RE: EWO – Olympic Steel (S20A0480A)

Nucor Building Systems has completed an engineering analysis of existing Nucor job #S08A0480A. The EWO included investigating the impacts of updating the building code to IBC 2018. The follow loads are as follows:

PROJECT NAME: OLYMPIC STEEL  
 SUMTER, SC  
 CUSTOMER: THOMPSON TURNER CONSTRUCTION CO.  
 SUMTER, SC

**CROSS SECTION @ LINES 10-18**

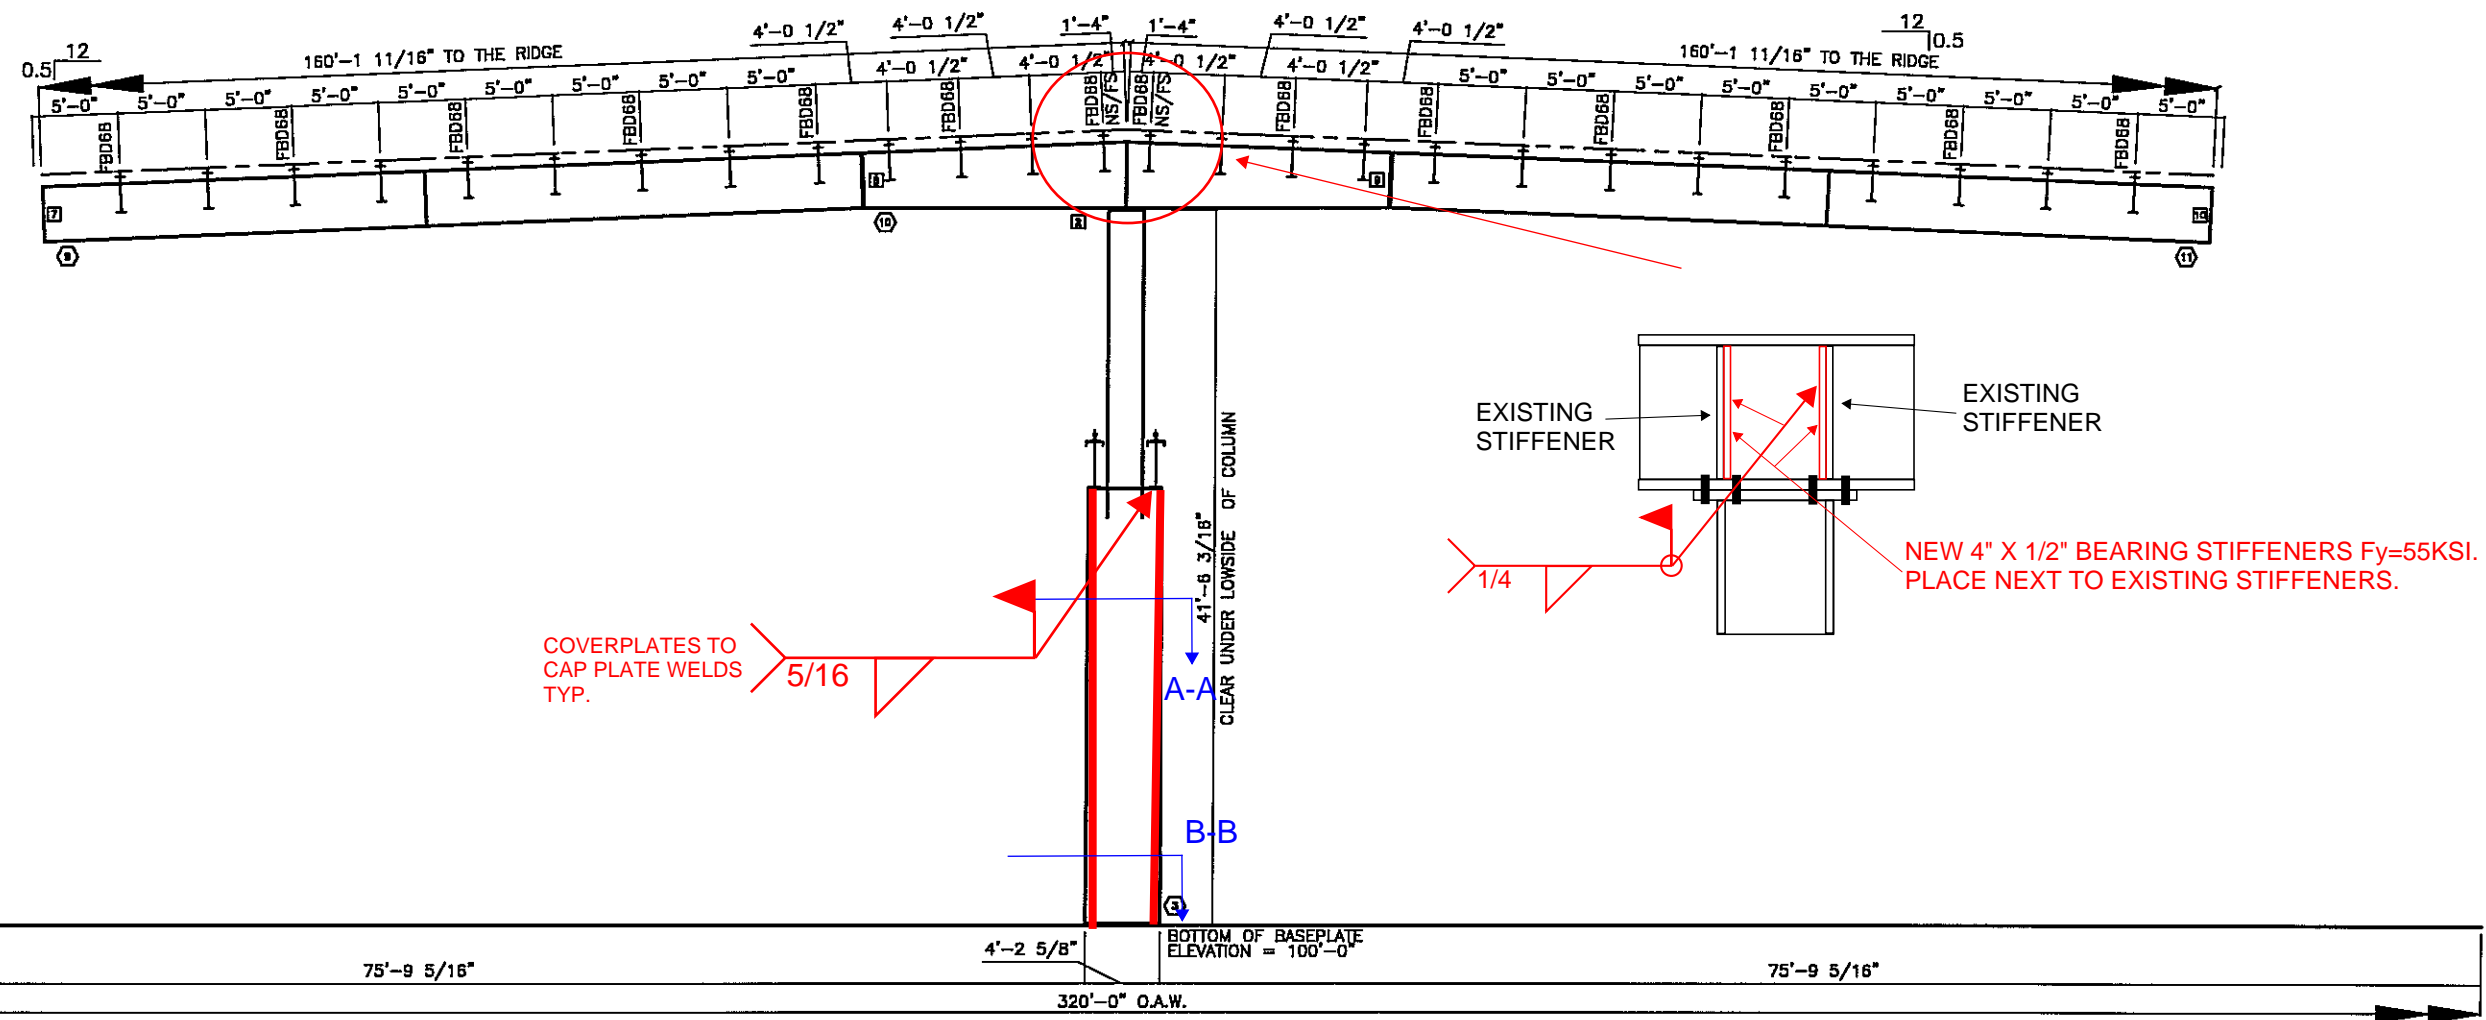
- 1) Frame lines 10-18 will require the following reinforcements:
  - a. The column flanges on lines E, J, and P will required cover plates.
  - b. The stiffeners in the fixed base connection will be field cut back to allow the cover plates to extend to the base plate.

- c. The moment connections above the columns on lines E, J, and P will require bearing stiffener reinforcements.
  - d. (2) Endplates per frame (10 total) will require bolt replacements.

CROSS SECTION @ LINES 10-18

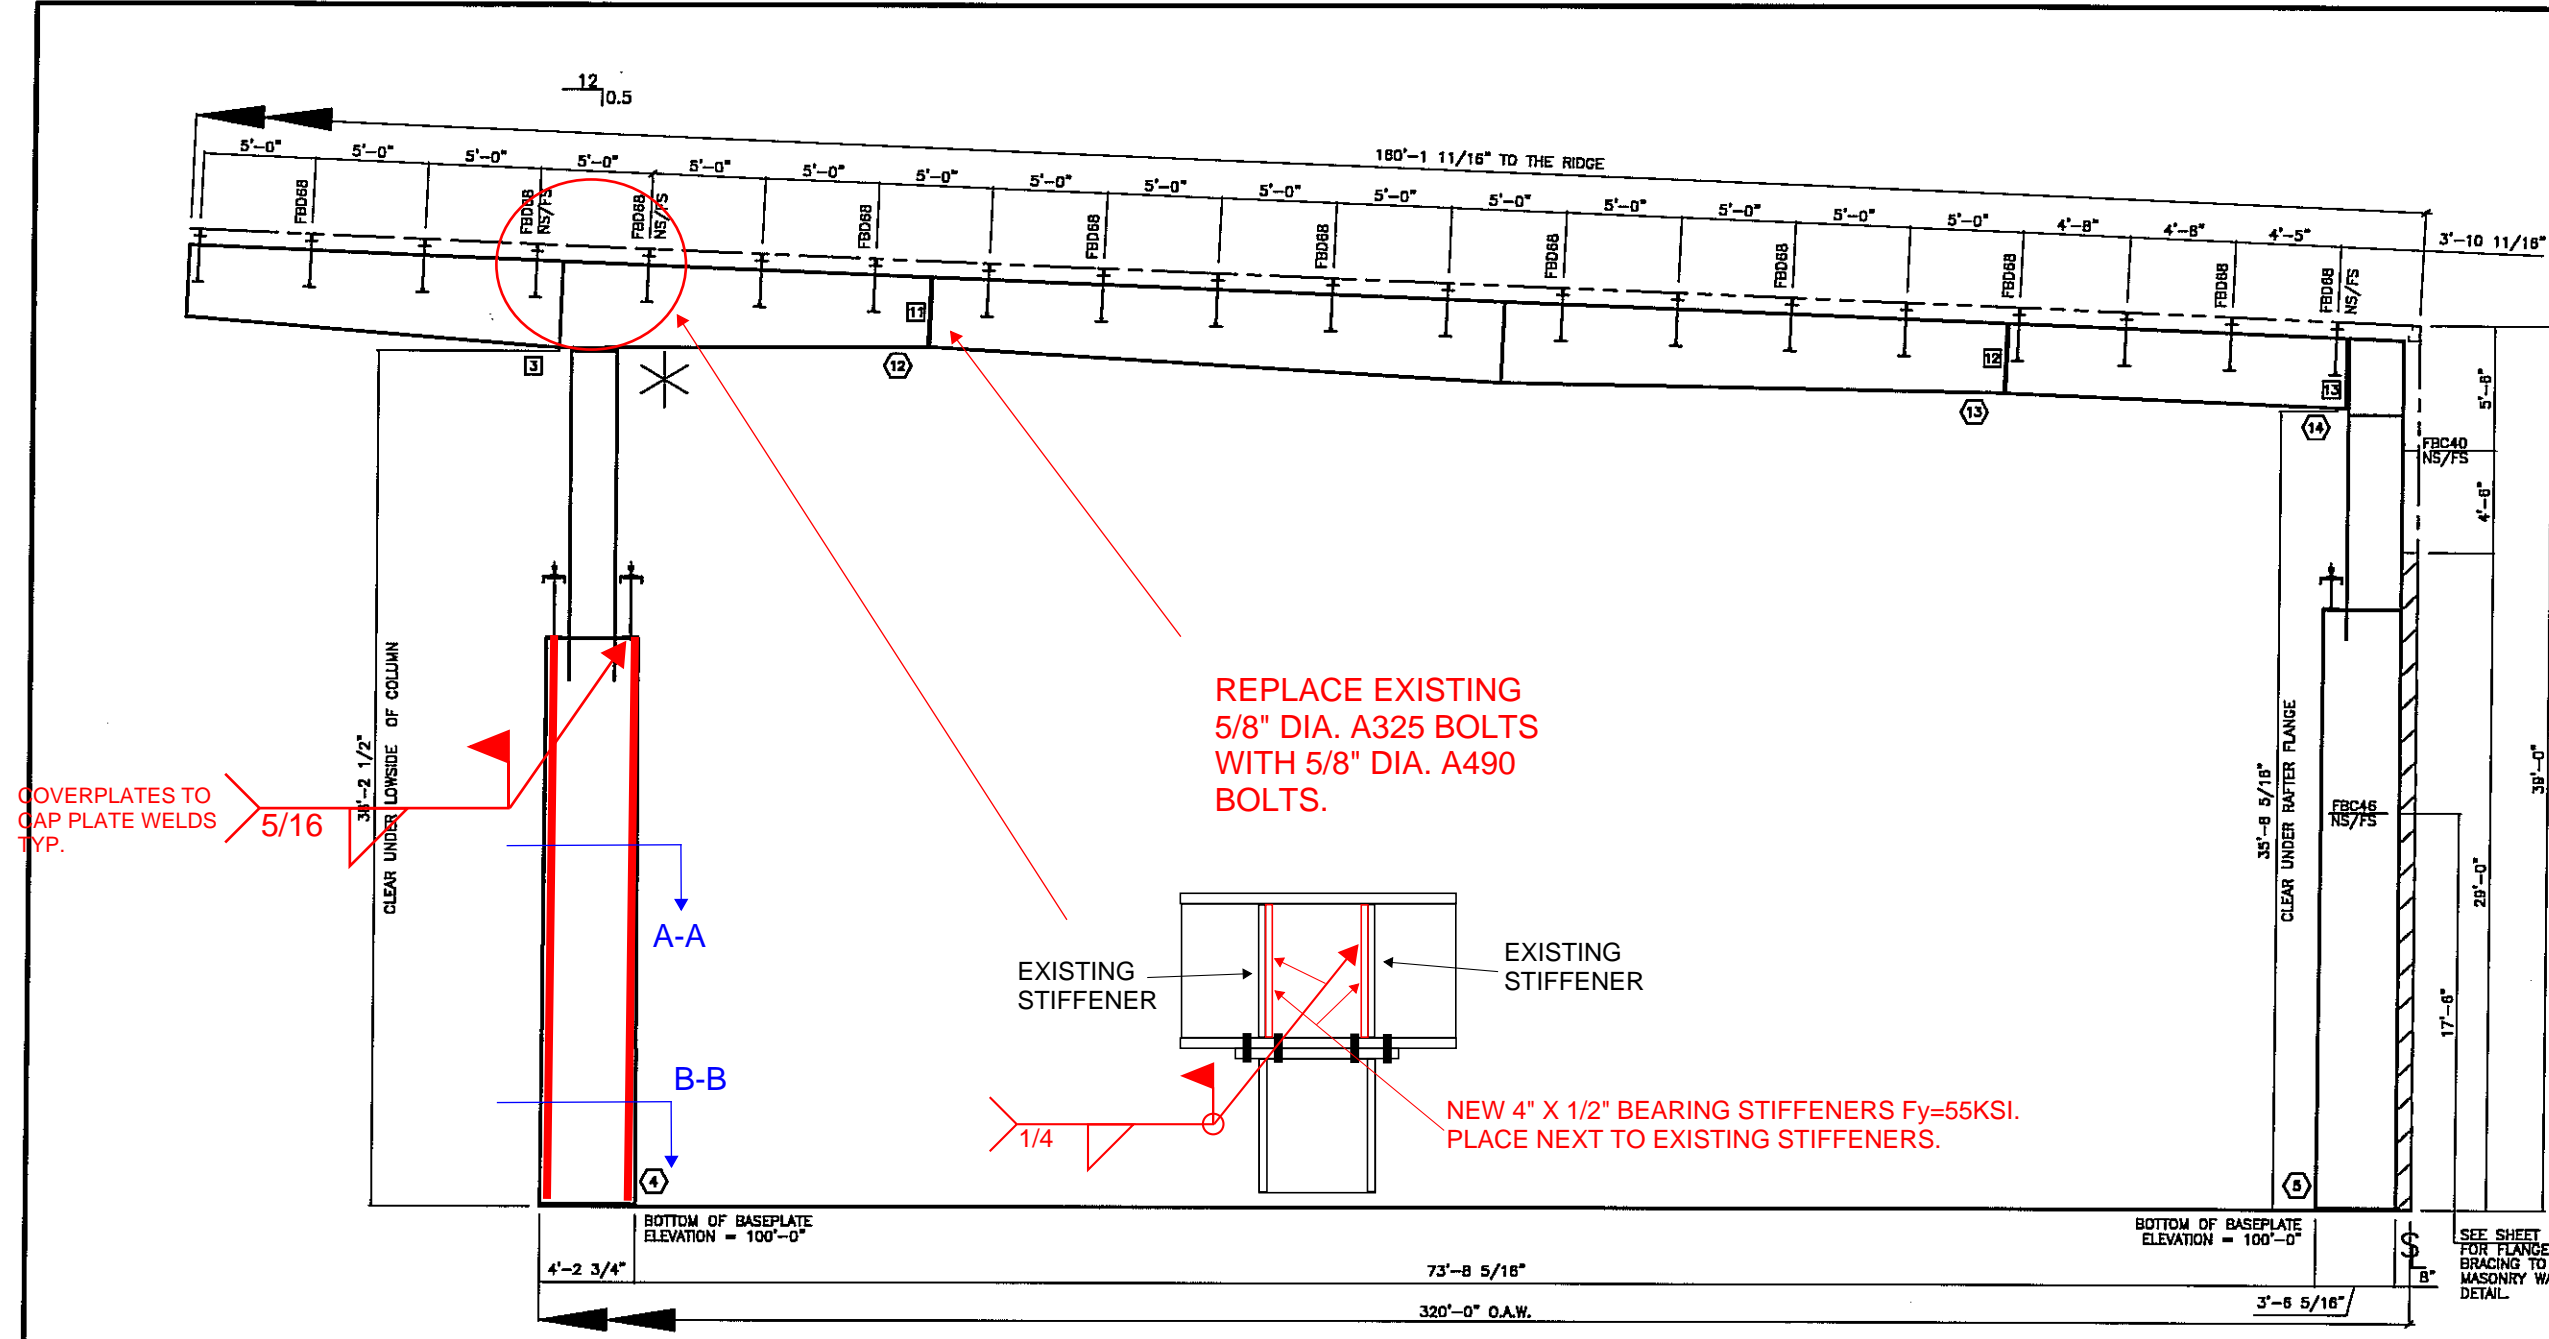
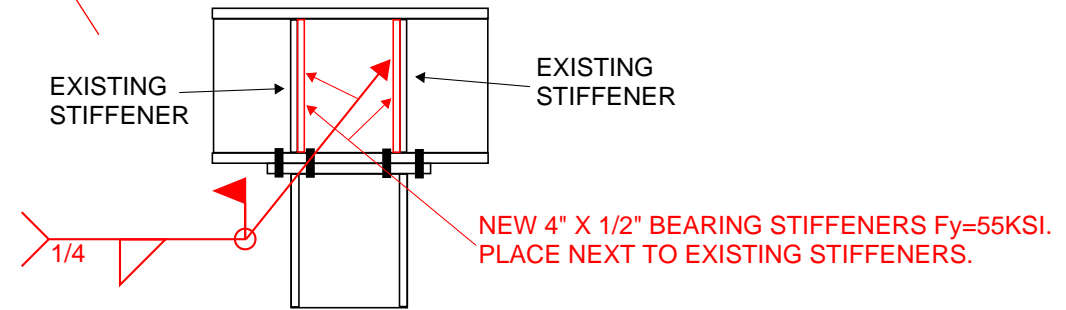
COVERPLATES TO GAP PLATE WELDS TYP. 5/16

REPLACE EXISTING 5/8" DIA. A325 BOLTS WITH 5/8" DIA. A490 BOLTS.

CROSS SECTION @ LINES 10-18

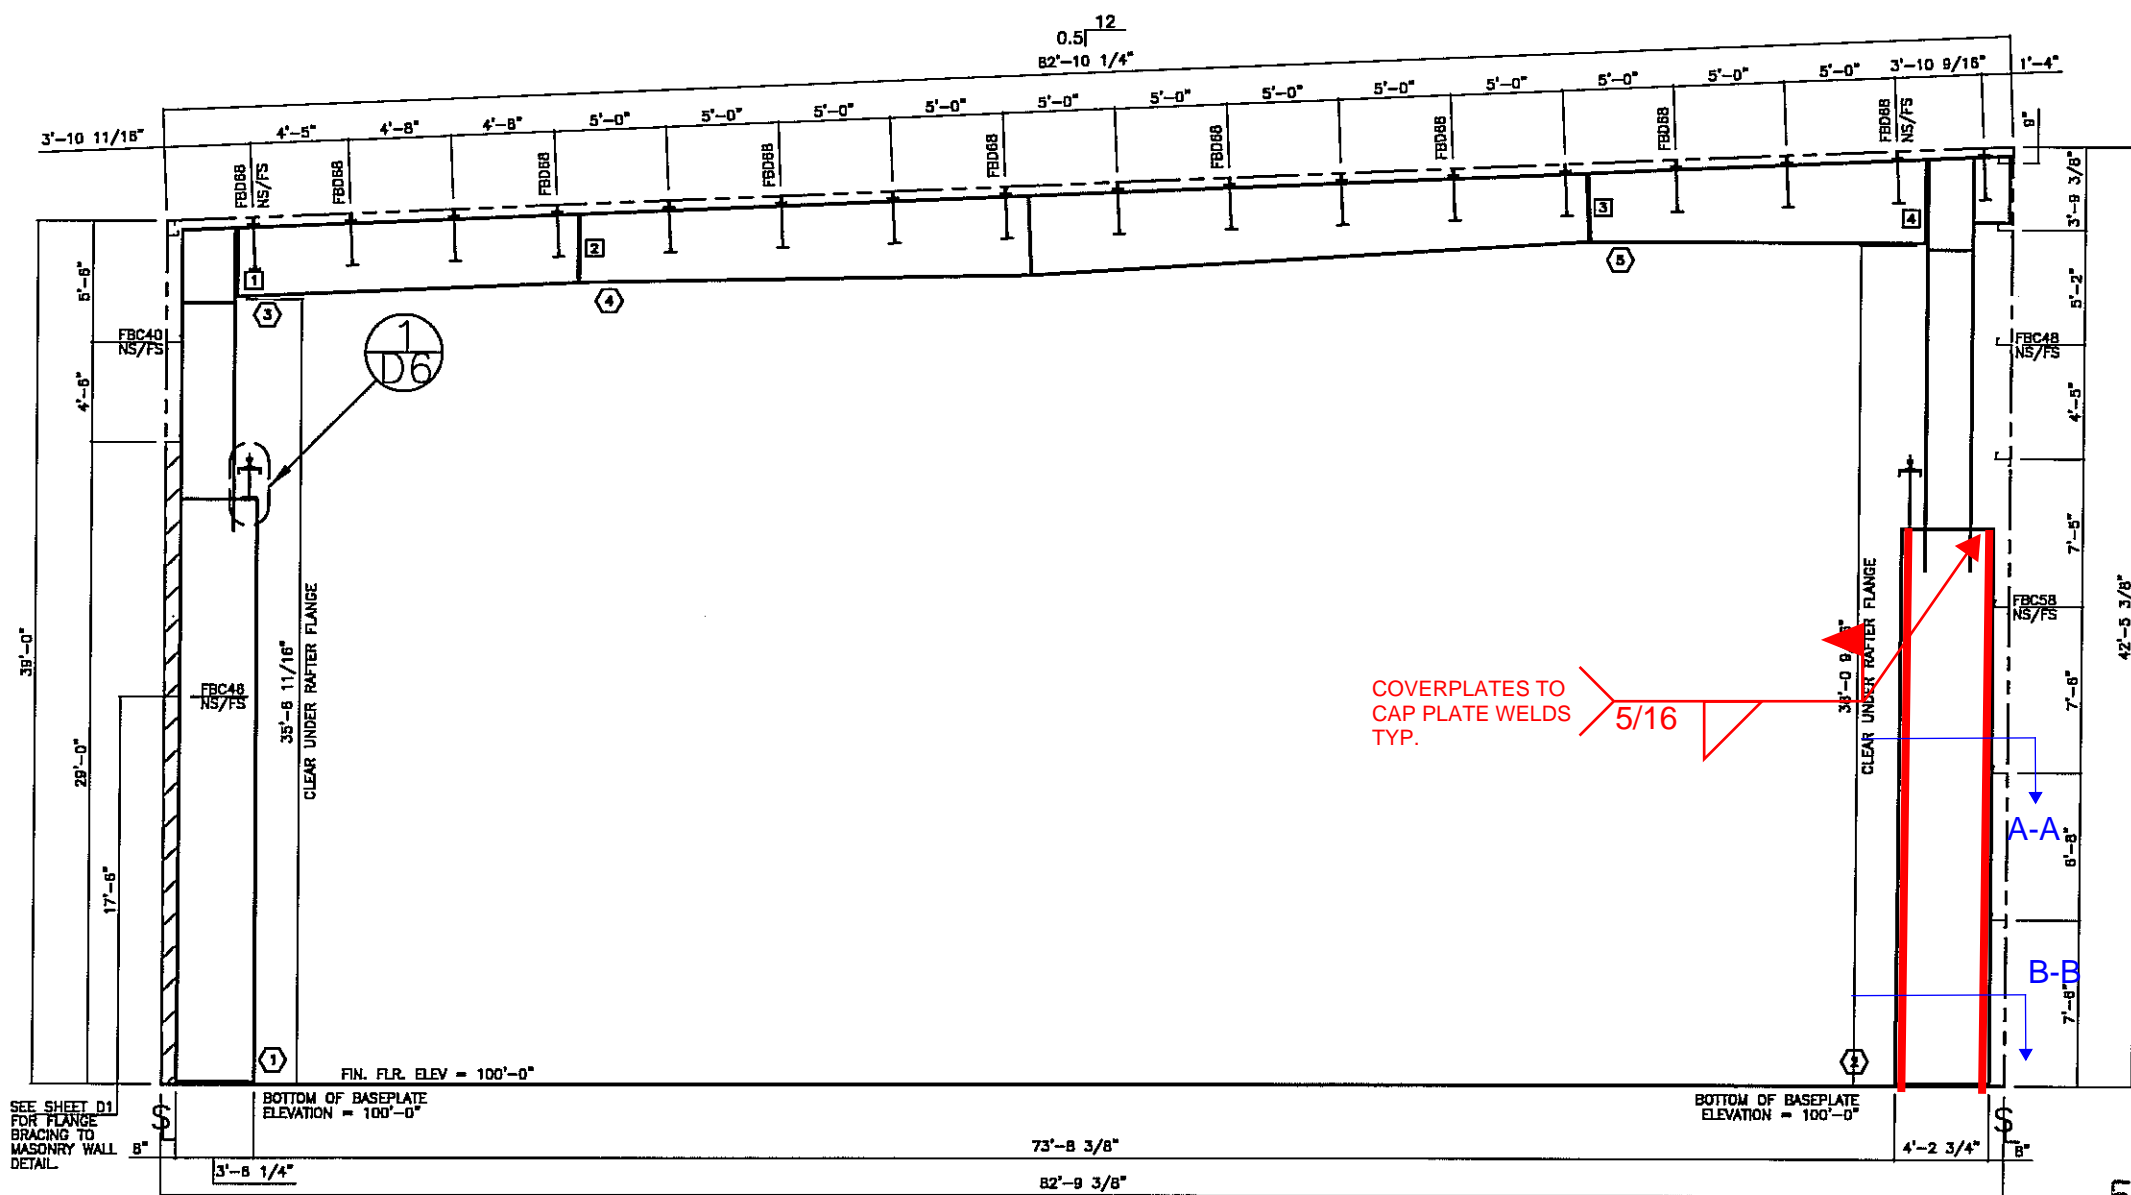
- e. See pages 3-5, and 10 for the fieldwork required.
- 2) Frame lines 1&3 will require the following reinforcements:
  - a. The column flanges on line N will required cover plates.

- b. The stiffeners in the fixed base connection will be field cut back to allow the cover plates to extend to the base plate.
  - c. See pages 6-7, and 10 for the field work required.
